**LINCOLN CITY/LANCASTER COUNTY PLANNING STAFF REPORT**

**for May 14, 2003 PLANNING COMMISSION MEETING**

**P.A.S.:** Special Permit #2010

**PROPOSAL:** A community unit plan for 66 residential units with waivers to the subdivision ordinance requiring a preliminary plat, to allow the Planning Director to approve administrative final plats, and to allow the approval of administrative final plats accepting the dedication of streets and private roadways.

## C.U.P. GRADING & DRAINAGE

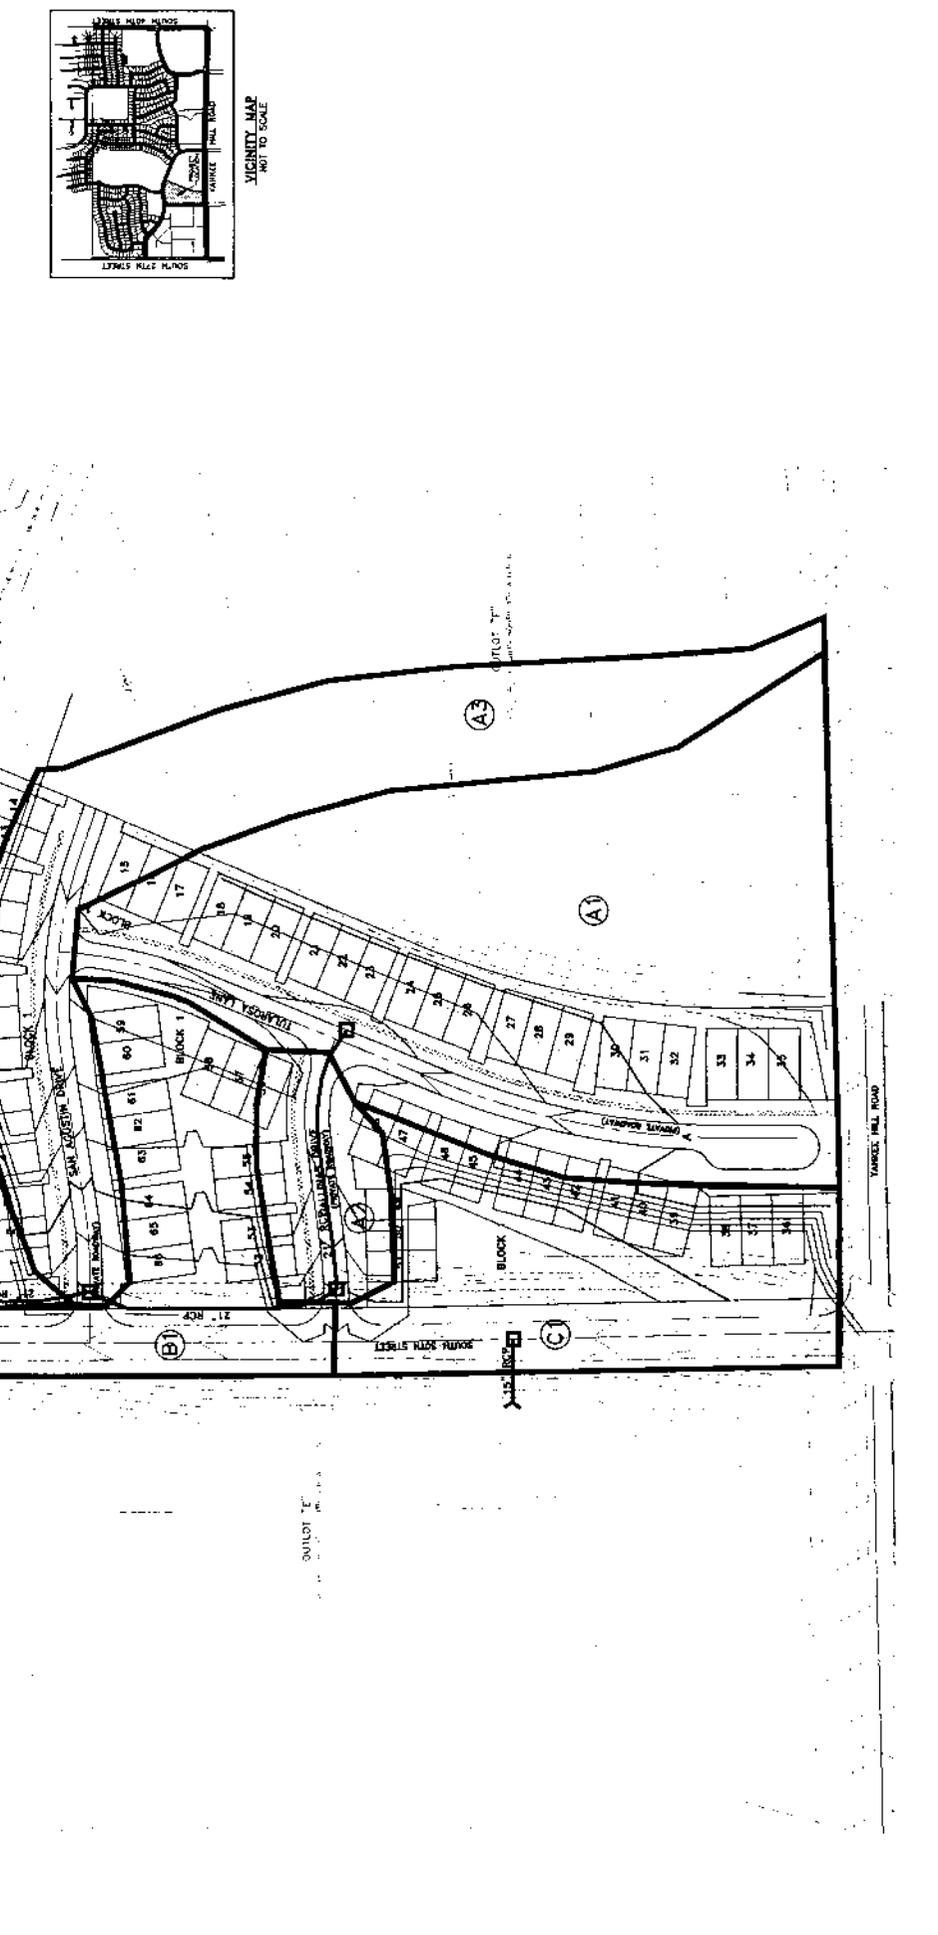
9. The grading and drainage plan must accommodate the 100-year storm event. This plan must be revised and approved by Public Works.
10. In their review, LES noted that additional utility easements must be granted to provide service to this project.

Grading/Drainage - The Pine Lake Heights South 4th Addition drainage study accounted for detention for the area of this project. However, as shown, the private storm sewer inlet system will need to be designed to pick up the 100yr storm. If the storm sewer system is designed for the standard 5yr storm, any storm above the 5yr will by-pass the detention cell through the commercial area to the west.

- 1.3 Submit a recreation plan approved by the Parks and Recreation Department.
    - 1.4 Submit a revised grading and drainage plan approved by Public Works and Utilities.

PRELIMINARY STREET PROFILES

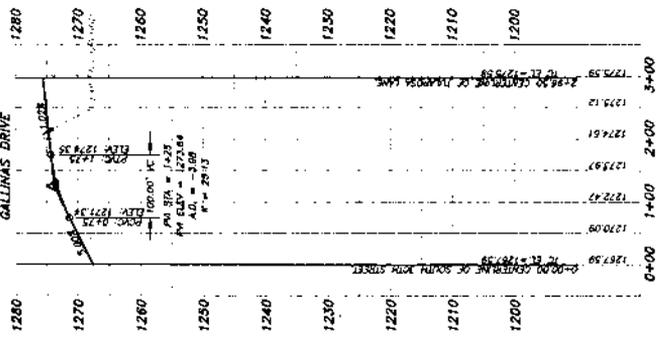
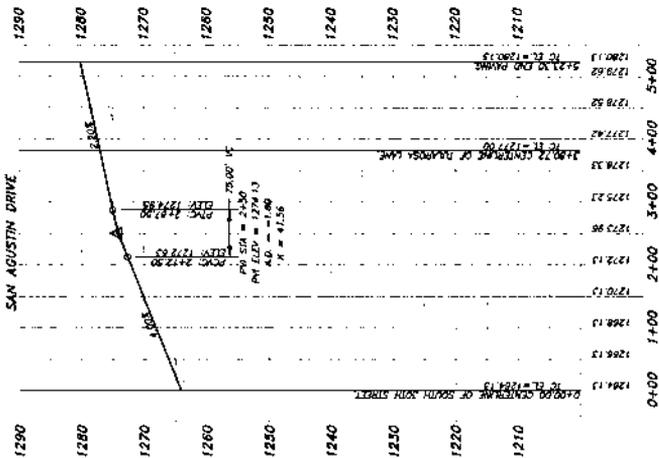
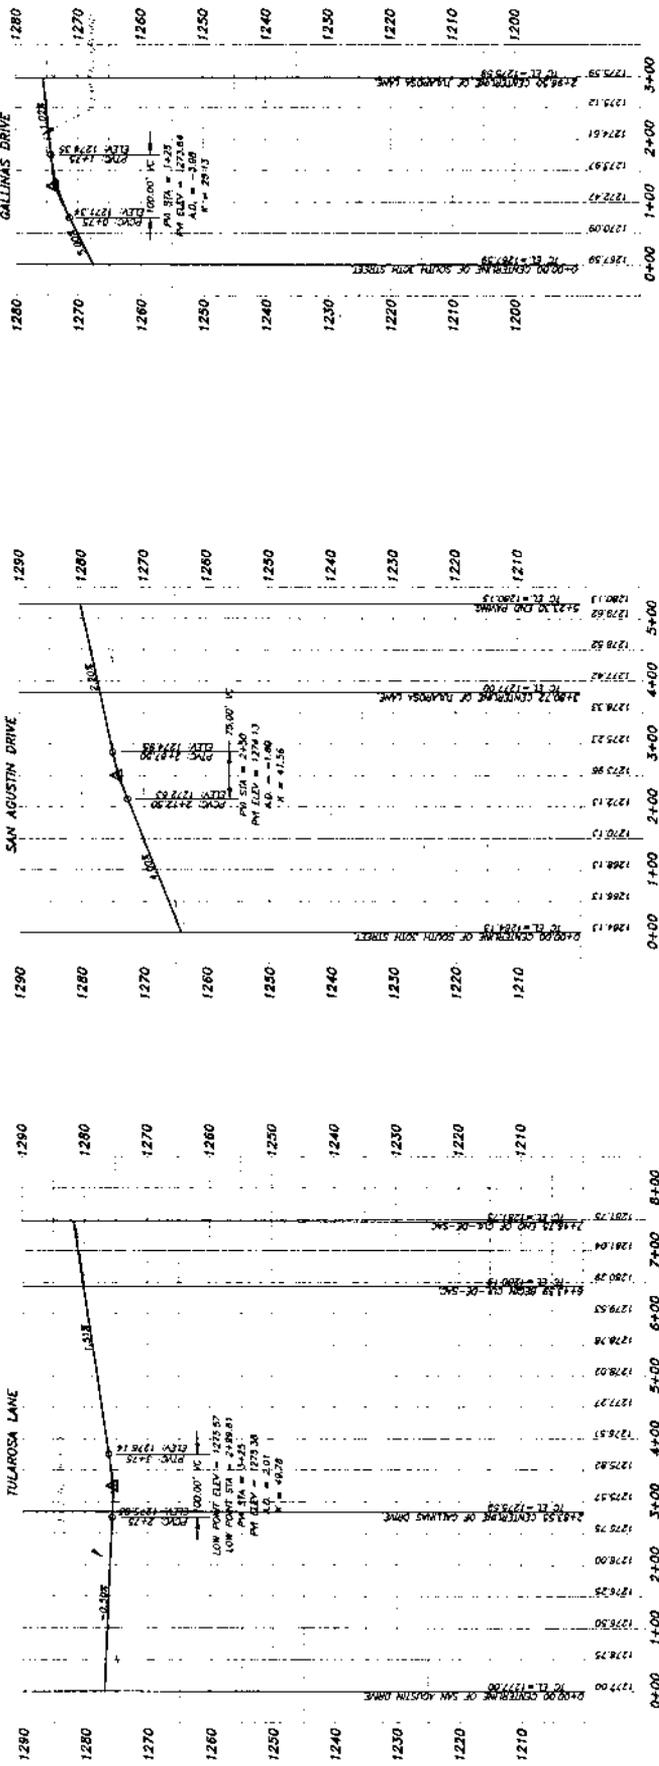
Streets - The waiver for intersection approach grades to South 30th Street from Gallinas Drive and San Agustin Drive does not appear to be justified. The profile for San Agustin Drive shows nearly 2' of fill for much of the street. In addition, there are portions of the grading plan that show up to 8' of cut and up to 6' of fill. This does not indicate an attempt to minimize site grading.

- 1.1.3 Show the tangent length of the curve at the intersection of Gallinas Drive and Tularosa Lane designed per Design Standards.
- 1.1.4 Show the required slope at all intersection approaches per Design Standards.

## C.U.P. LANDSCAPE PLAN

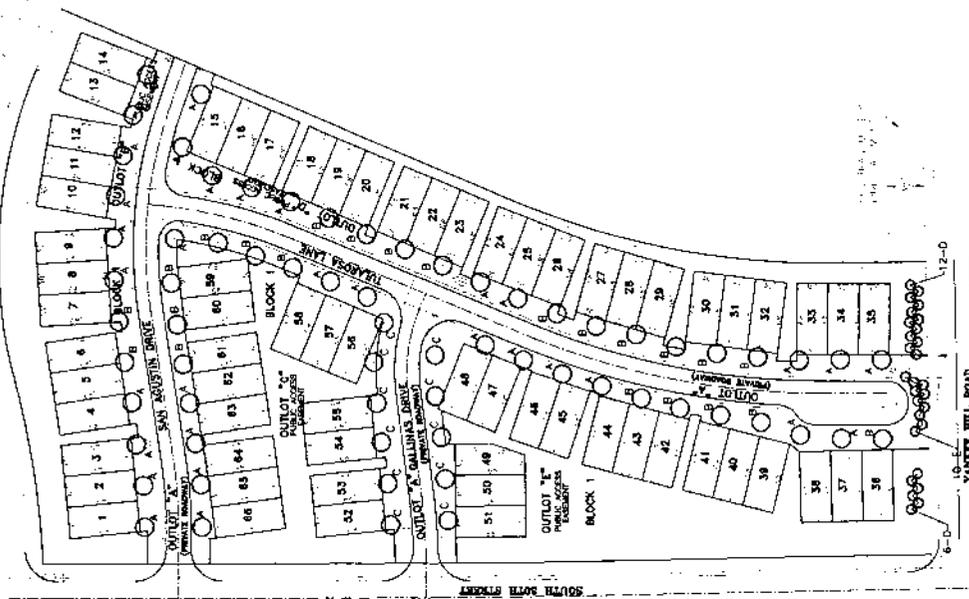
12. Design Standards require that a 50% screen from 6' to 15' in height must be provided around the perimeter a CUP. The landscape plan must be revised to show this required screen.

1. Austrian Pine is not an acceptable tree species. Substitute with one of the following evergreens: Concolor Fir, Colorado Green Spruce, Colorado Blue Spruce, Black Hills Spruce, or Cedar.
2. All outlot areas to be maintained by the developer and/or future homeowners association.
3. Provide street trees on Grainger Parkway, South 30<sup>th</sup> Street and Yankee Hill Road.
4. If cul-de-sac island beds and eyebrow island beds exist as referenced in the landscape notes, please indicate the location on the landscape plan.
5. A community outdoor recreation plan needs to be developed. Include ½ court basketball court, seating area, and tot lot for children ages 2- 5. Submit plan to the parks department for review.

- 1.1.16 Clearly show the boundary line separating Outlots A and D and Outlots A and B.
    - 1.2 Revise the landscape plan to:
      - 1.2.1 Substitute Austrian Pine for an acceptable species noted by the Parks and Recreation Department.

- 1.2.2 Show street trees along Grainger Parkway and South 30<sup>th</sup> Street.
      - 1.2.3 Show a landscape plan for island beds.
      - 1.2.4 Provide screening per Design Standards.
